PLANNING TECHNICAL REVIEW COMMITTEE –AGENDA

Meeting Type: Regular Meeting
Meeting Location: Council Conference Room, City Hall, 288 Central Ave, Dover NH 03820
Meeting Date: **Thursday, August 31, 2023**
Meeting Time: **10:30 AM**

PLAN SNAPSHOT REPORT SITE-2023-0011 FOR CITY OF DOVER, N.H.

Description: Proposed 3,300 sq ft - Bank with Drive-Up ATM

PSU SIDE VIEW

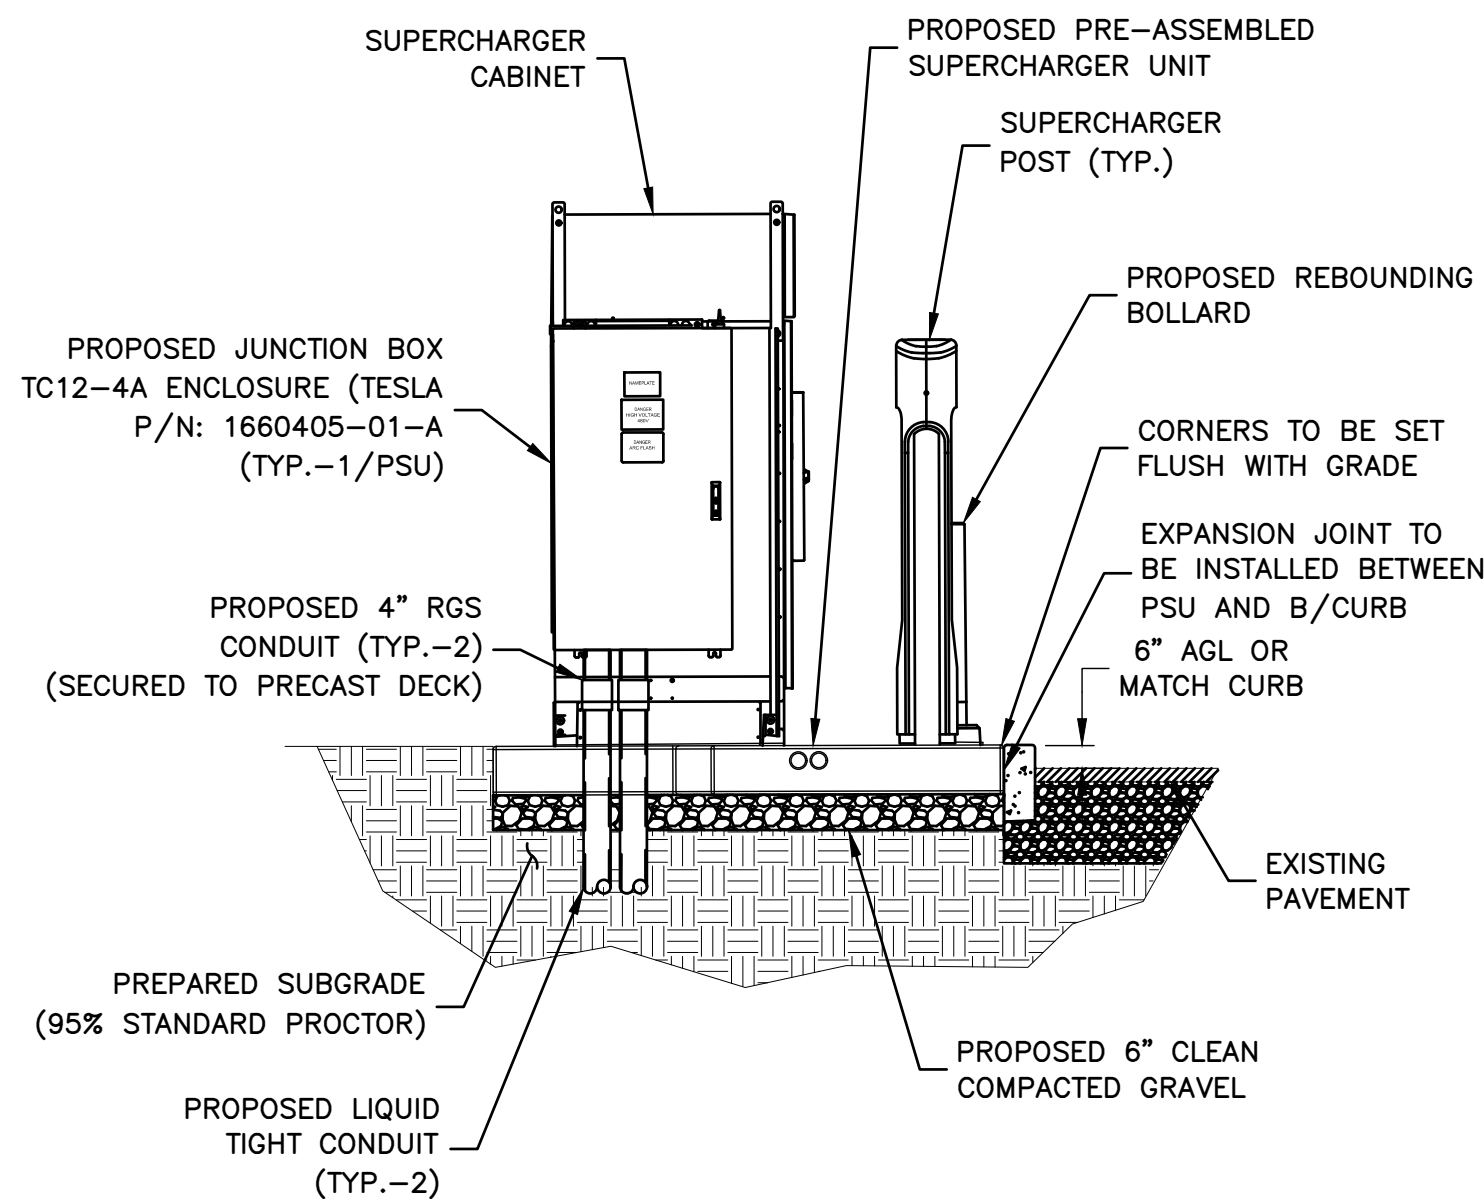
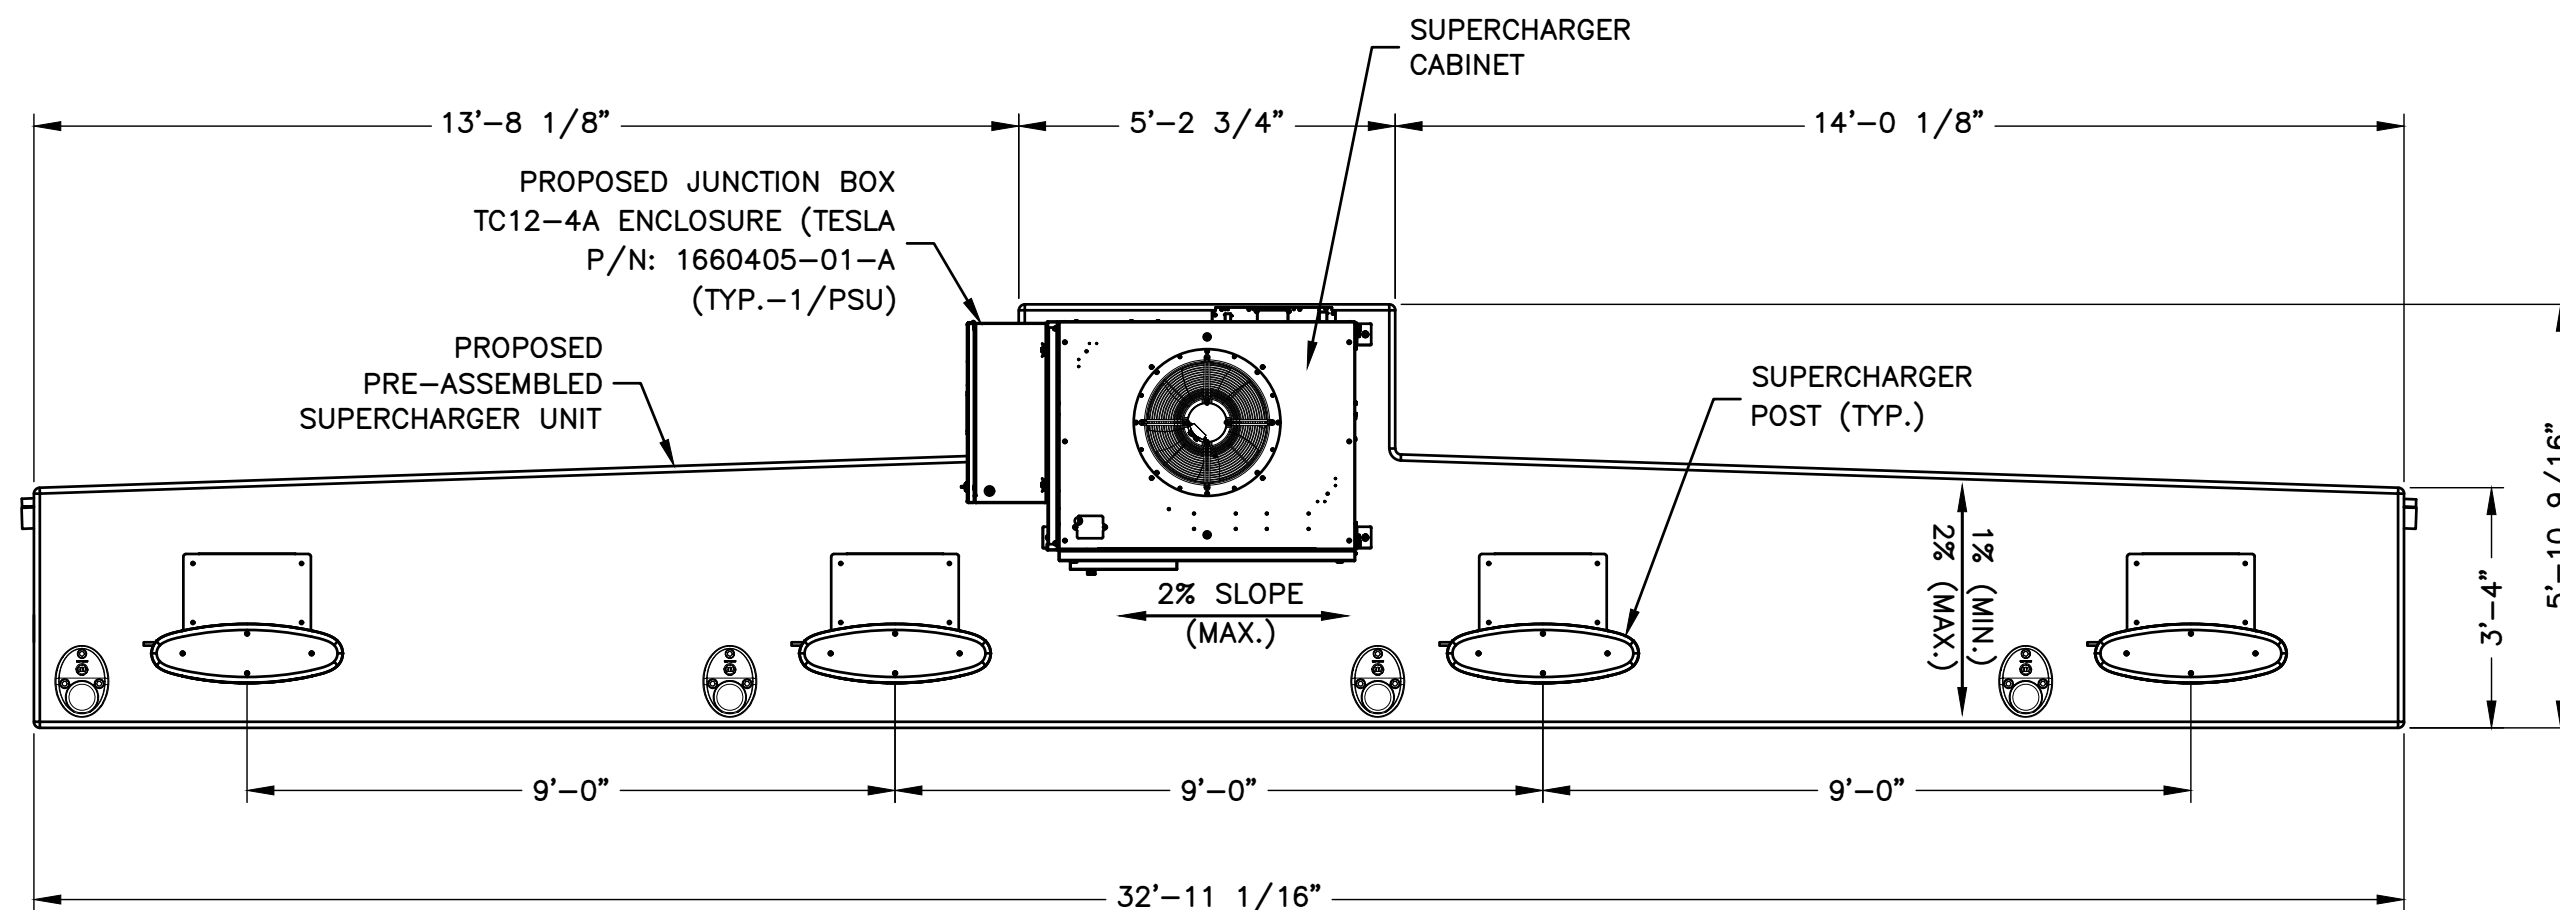
- Recommend showing radius of proposed curbing
- C-4:
 - Detail 3: confirm if charging unit is to be flush as shown, or if there will be a curb reveal as shown in the elevation views and to match existing conditions.

o Detail 3: confirm if charging unit is to be flush as shown, or if there will be a curb reveal as shown in the elevation views and to match existing conditions. - **The top of the PSU will be flush with the top of the granite curb. The standalone charger for the ADA stall will be flush with the existing pavement.**

McCUE REBOUNding BOLLARD & SIGN

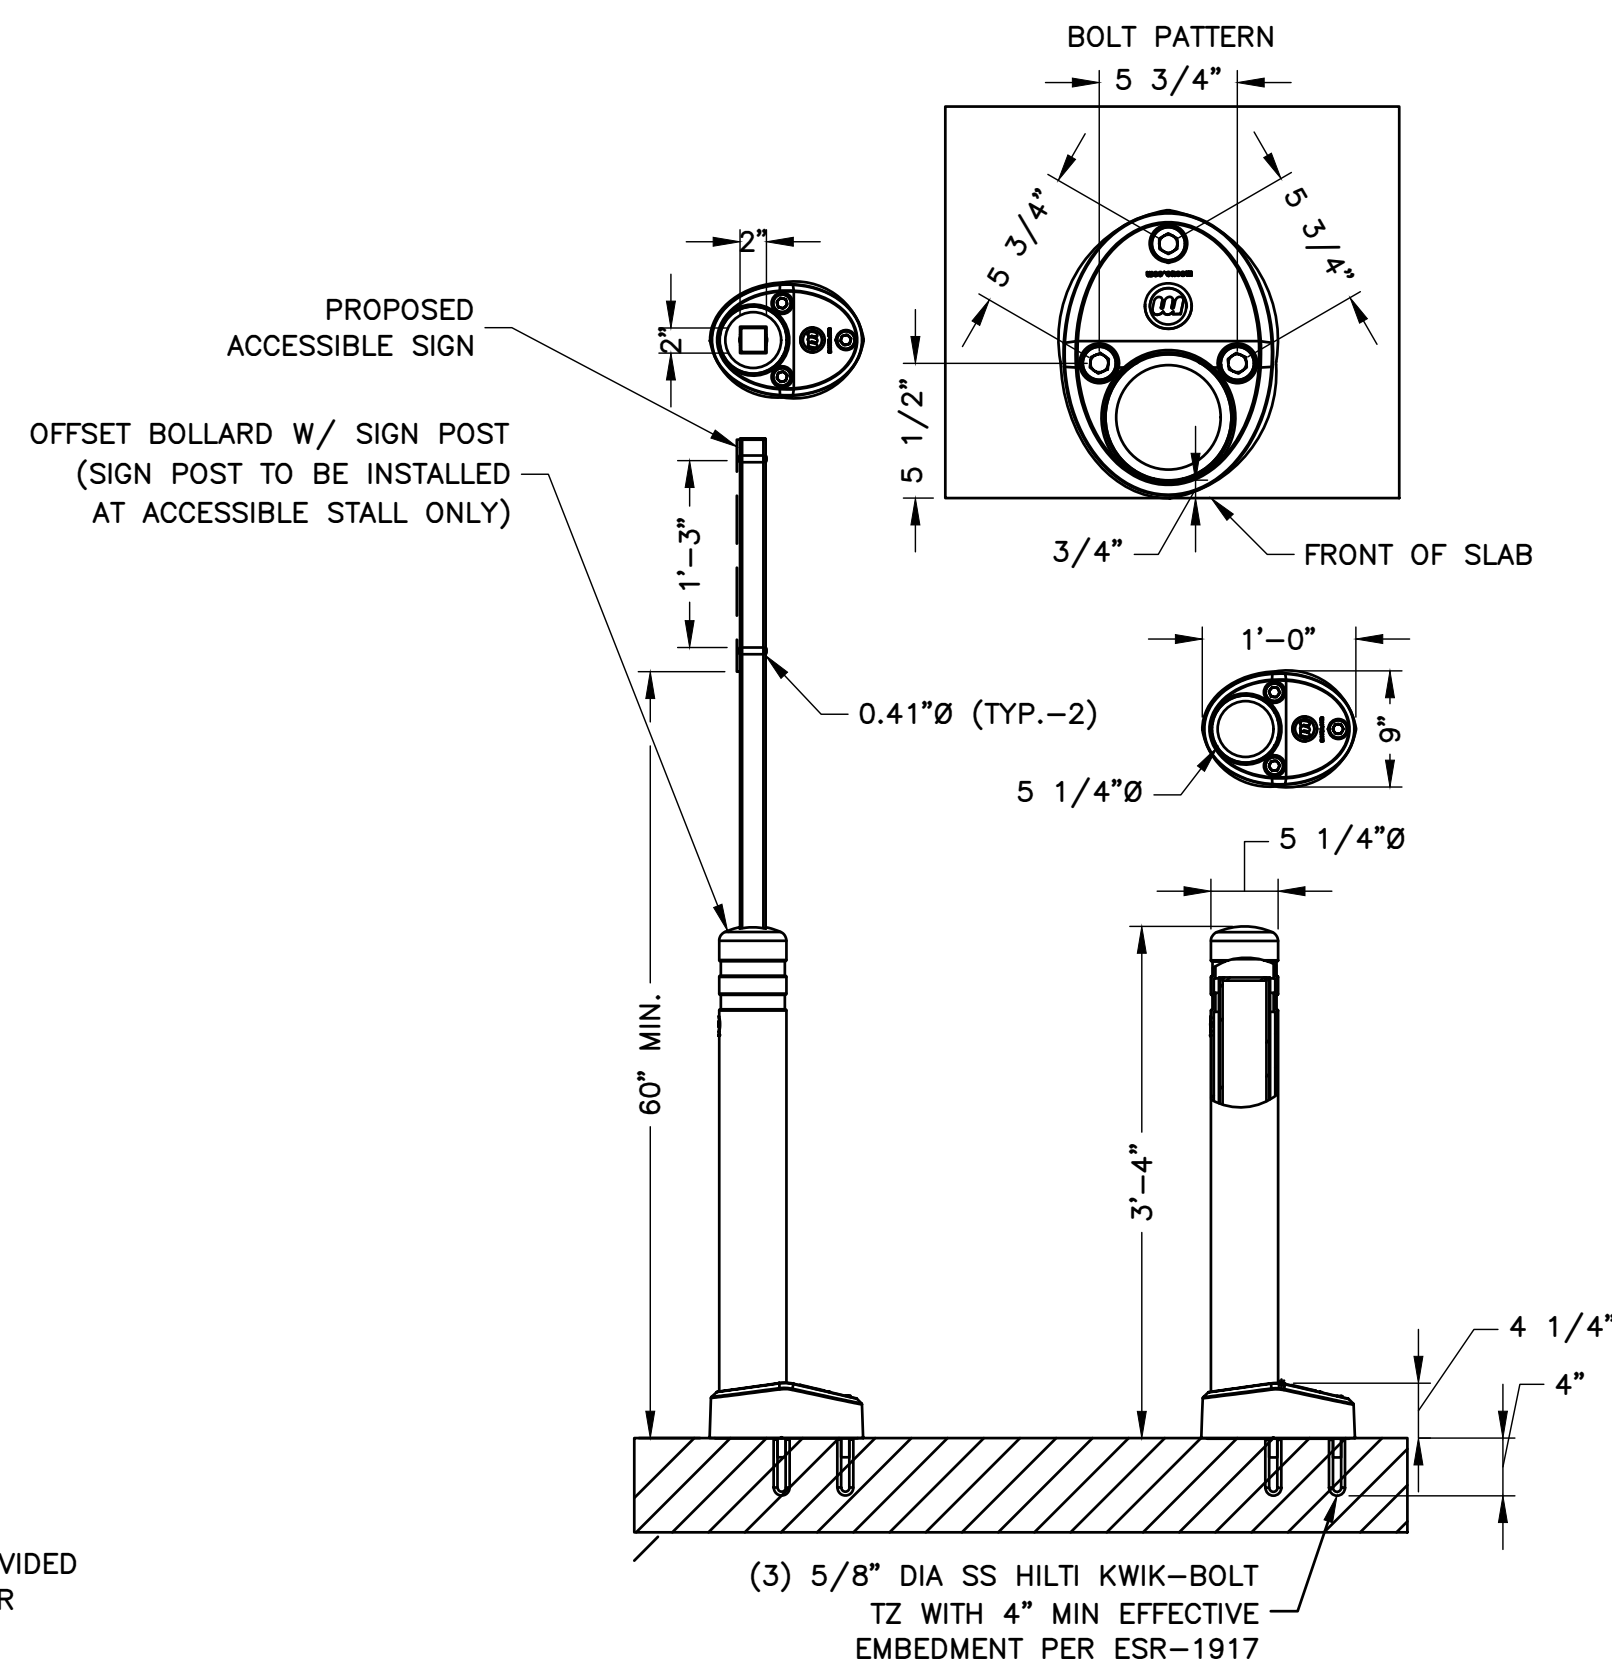
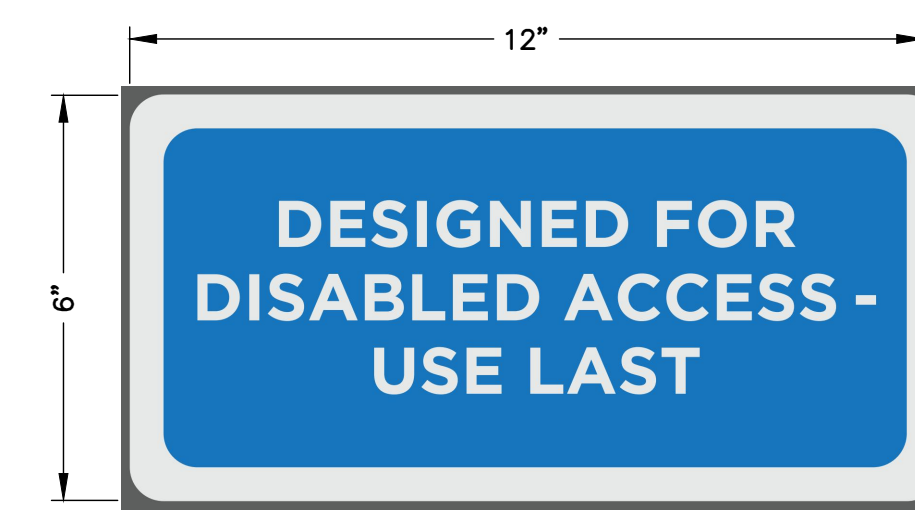
- Show/indicate where on bollard accessible signs will be placed; height of signs from pavement.
- Detail 7: confirm existing and proposed curb is to be granite

o Show/indicate where on bollard accessible signs will be placed; height of signs from pavement. – **Completed on sheet (8) C-4 detail 4 & (10) C-6 detail 2.**
